HOWARD COUNTY HISTORIC PRESERVATION COMMISSION

2020 Minutes

February Minutes

Figure 5 - Proposed primary location

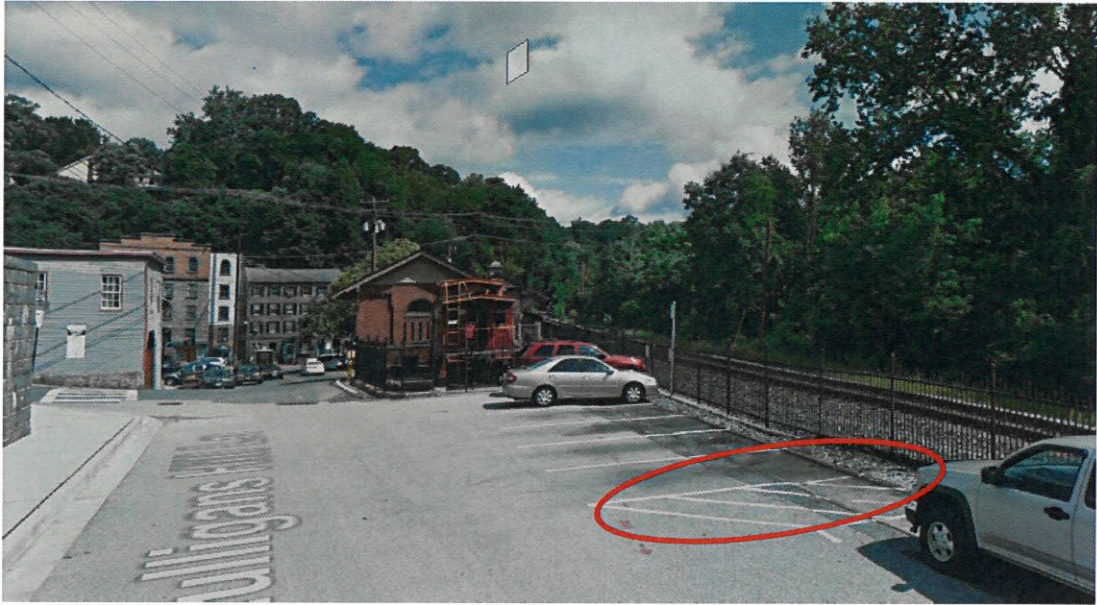
The proposed location for installation at 3711 Maryland Avenue/Parking Lot C is behind the train caboose, within Parking Lot C. This location is approximately 60 feet from the edge of the caboose. The alternate location (which depends on utilities, etc.) is at the parking spot directly behind the caboose, approximately 10 feet from the back of the caboose.

Ms. Tennor said that Mr. Meyer proposed a primary and an alternate location. Ms. Tennor did not understand why an alternate location would be needed. Mr. Meyer said that the first location would work best for OEM due to traffic patterns but wanted to include an alternate location in case the primary location was not acceptable to the Commission. Ms. Tennor asked if the alternate location was not as effective, but less visible than the primary location. Mr. Meyer said that was correct. Ms. Tennor asked why the primary location worked better. Mr. Meyer explained that primary location would not interfere with parking spaces, but that placing the pole in the alternative location would result in the loss of a parking space.

Figure 8 - Site layout

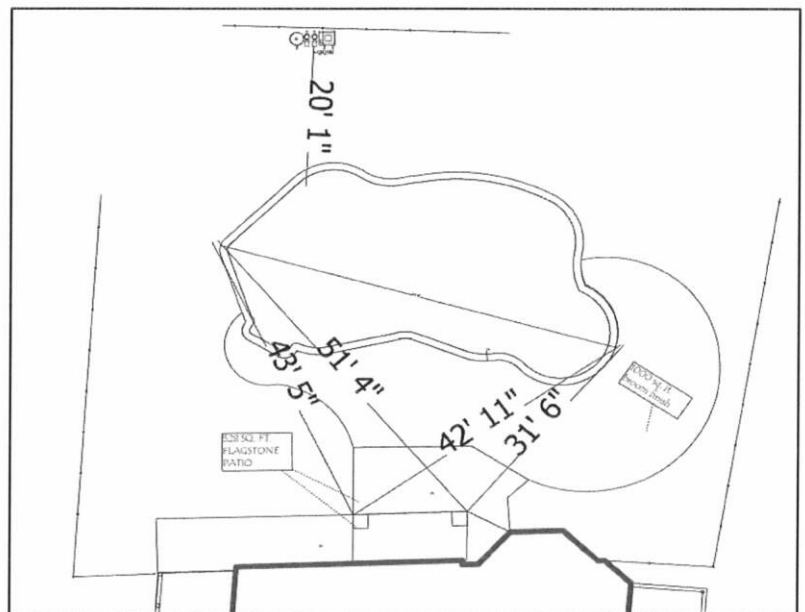
- Item 4 – Pool Accessories (stepping stones, boulder feature, slide with raised bed to support the boulder and slide).
- Item 5 – 1000 square foot broom finish concrete patio (aka pool decking) surrounding pool and 528 square foot flagstone patio extension (previously was proposed to be brick to match existing, it will now all be changed to flagstone).
- Item 6 – Four-foot-tall black aluminum fencing, in the Antietam style.

The applicant has submitted the following renderings to depict what the proposed fencing, flagstone patio and concrete patio (pool decking) would look like. The proposed slide will be tan in color and will be 8-feet 3-inches high at full height. The applicant will return with landscaping in a future application.

Figure 14 - Proposed scoring pattern

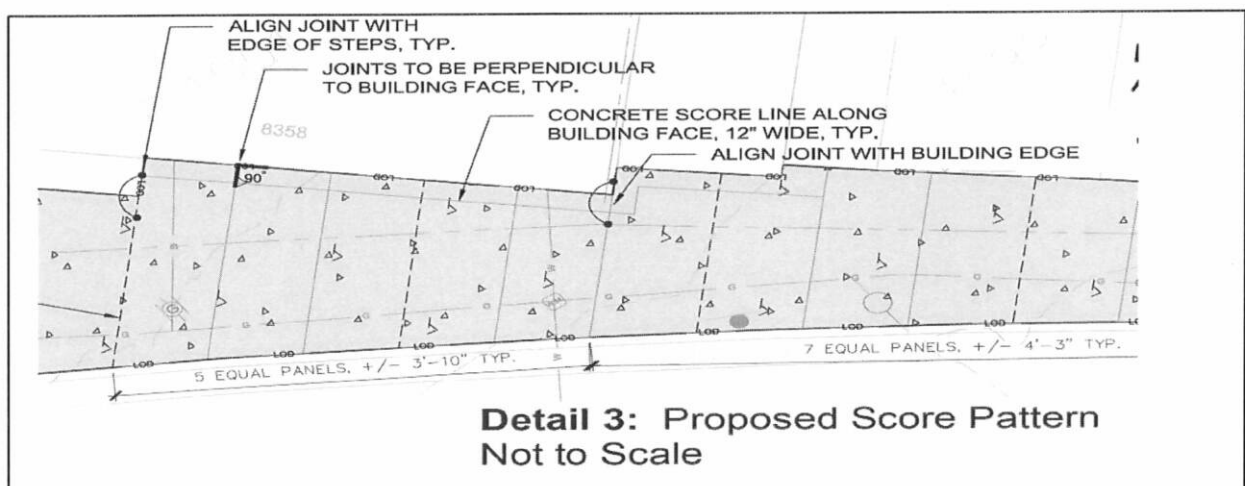
Over the course of these three meetings, the Commission had many questions on replacement sidewalks and expressed a desire to see brick sidewalks reinstalled in the future. The Commission seemed to generally agree that concrete was acceptable in places where sidewalks were largely destroyed in the floods, and as a result, are now mostly bituminous. In the areas where brick survived the floods and only had small areas of bituminous patchwork, the HPC found that brick should be used as the replacement material for the bituminous patch.

Figure 15 - Areas of proposed concrete replacement and brick repair

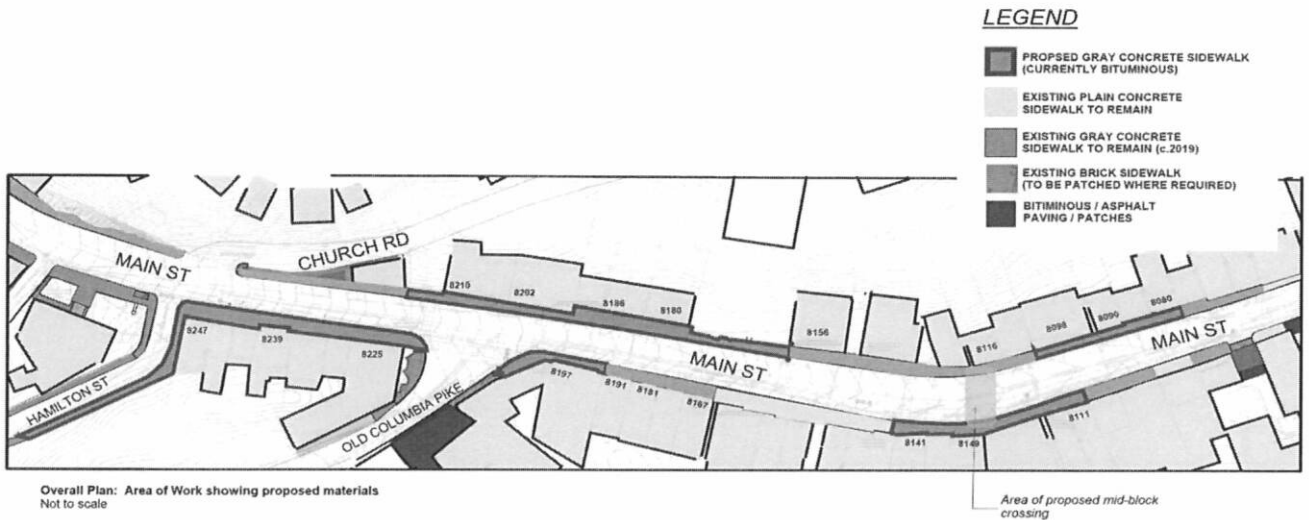
The concrete sidewalks are proposed for the specific context of flood resiliency. The proposed sidewalks will be simple in design. Prior to the brick sidewalks being installed in the 1990s, the sidewalks were all concrete. Research reveals that many different materials have been used for sidewalks in Ellicott City over the years, but an original sidewalk material has not been determined.

Figure 17 - Original location of wall

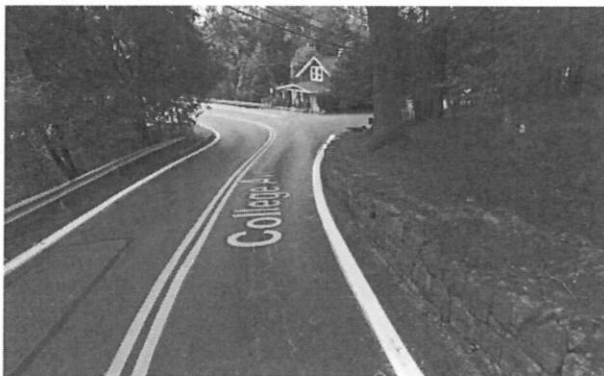
The application explains that the stone walls have been hit numerous times over the years by vehicles. The applicant has been working with the Department of Public Works (DPW) on a plan for the roadway and has contacted HPC staff over the last few years to discuss the wall and potential plans. On December 9, 2019, HPC staff, DPW and the applicant met on-site to review the work that had been done and the work that was yet to be completed due to the trees that needed to be removed.

Figure 1 - Corrected view of shed dormer to reflect siding instead of roofing shingles.

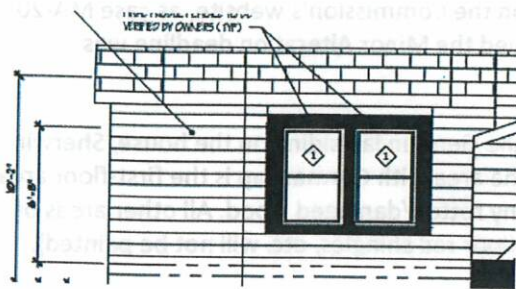
The elevation incorrectly shows roofing shingles on the revised shed dormer, instead of siding. The applicant noted that was to remain siding and not become roofing shingles and submitted an edited view of this elevation to correctly show siding.

Figure 6 - Existing garage

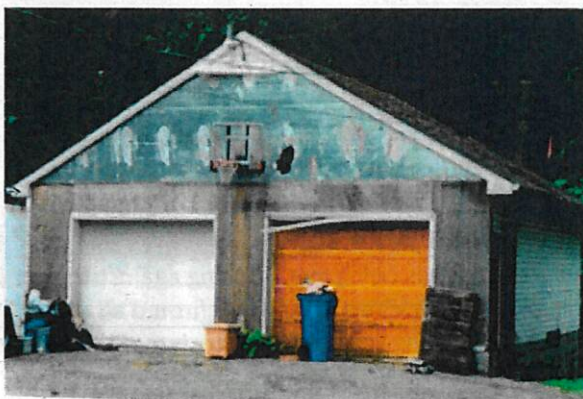
Ms. Zoren said in Figure 6 of the staff report, there was an existing garage with a basketball hoop, and noted the siding on the garage in Figure 6 did not have vinyl siding. Ms. Zoren asked if Mr. Engebretsen was proposing to add vertical wood siding on that garage as well.

Figure 20 - Historic house in the Tudor Revival style at 3958 Old Columbia Pike

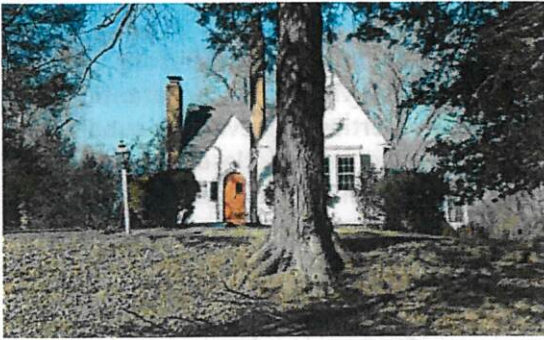
The new homes are shown in a “modern craftsman style,” which is not compatible with the existing historic house at 3958 Old Columbia Pike. The house at 3958 was constructed in the Tudor Revival style. The examples provided of the new homes will be significantly larger than the existing historic house, share no similar architectural features, and impact the viewshed and setting of the historic structures.
